**WOKINGHAM
BOROUGH COUNCIL**

Full Planning Approval Consultation

Proposal: Full planning application for a new road to provide an alternative route to Waterloo Road from south of the roundabout at the junction of Waterloo Road with William Heelas Way to a point further east on Waterloo Road, together with a turning head between the two new junctions.

From:	Ben Amey, Highways Development Control		
Service	SDL Highways	App No:	250870
Address:	Land at phase 2b, Parcel R10 of the South Wokingham SDL.		
Proposal:	Section 73 Application for amendment of Planning Permission No. 240892 approved on 5 th February 2025.		
Type of Development:	Major All other developments		
Site Visit Made:	Yes/No

Abley Letchford Drawing No.A389-LR-106-P7 (Visibility Splays)

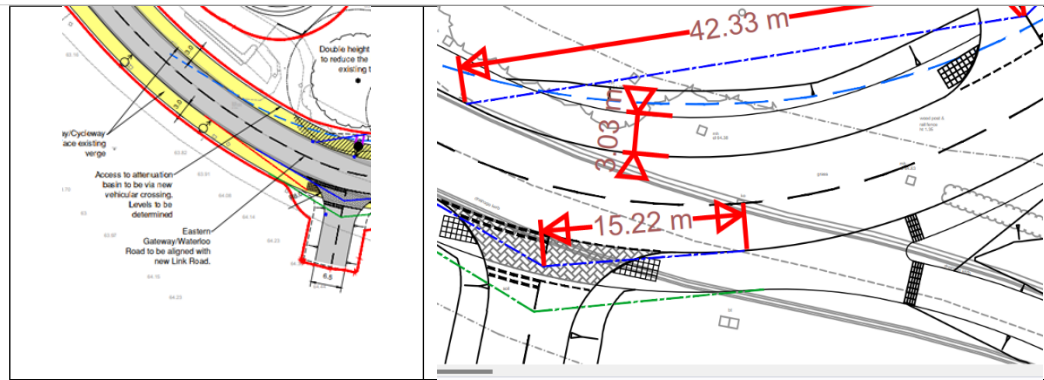
1. The LHA require the drawing is amended to demonstrate a suitable visibility splay from the vehicle access point for the attenuation basin and from all dropped kerb access junctions. The visibility splay is not provided for the new vehicular crossing labelled on the General Arrangement Drawing.
2. Some of the visibility Y distances shown do not appear to comply with a 30mph or 20mph speed limit (Y distances of 43m and 25m). Clarification is required as to why the Y distances shown are considered acceptable.

Abley Letchford Drawing No. A389-LR-111-Rev-P11 (Titled: *Refuse Vehicle Swept Paths*) dated 03.25.

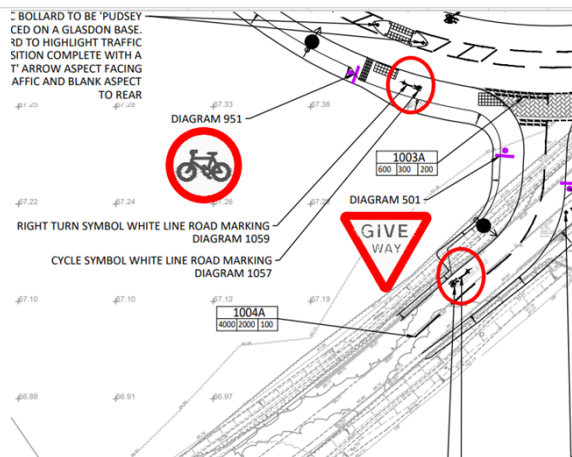
3. The LHA consider the refuse vehicle swept paths acceptable. The swept paths demonstrate that the access road is wide enough for two refuse vehicles to pass each other whilst travelling in opposite directions along the access road. The swept paths also demonstrate a large refuse vehicle can ingress/egress the internal junctions on the site access road without overswinging the centre line or without overrunning the kerb line. The swept paths have been completed for a Large Refuse Vehicle (4 axle) which measures 11.347m long.

Abley Letchford Drawing No. A389-LR-1201-Rev-P8 (*Traffic Signs and Road Markings*) dated 03.25

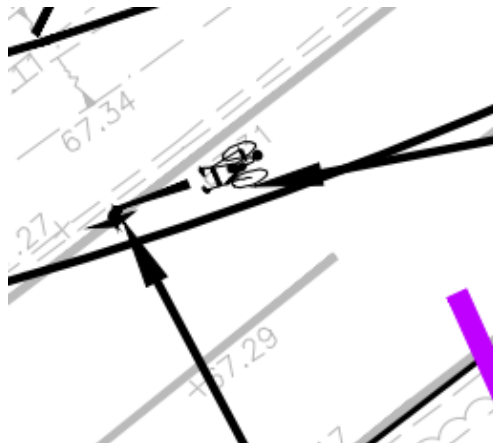
5. The LHA require confirmation that signs will be illuminated or reflectorised in accordance with Regulation 8 of the Traffic Signs, Regulations and General Directions (2016). The drawing does not state that any of the signs shown will be illuminated.
6. The LHA require provision of at least one blue shared use sign to TSRGD Diagram Sign 956 on the section of shared use footway between Waterloo Road and the South West Link Road. A screenshot of the section in question is provided below.

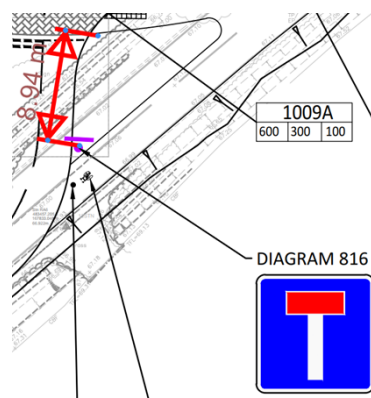
7. The LHA request confirmation that dropped kerbs will be provided in locations where the road markings direct cyclists to rejoin the carriageway or leave the carriageway and rejoin the shared footway/cycleway. An example location is shown below.
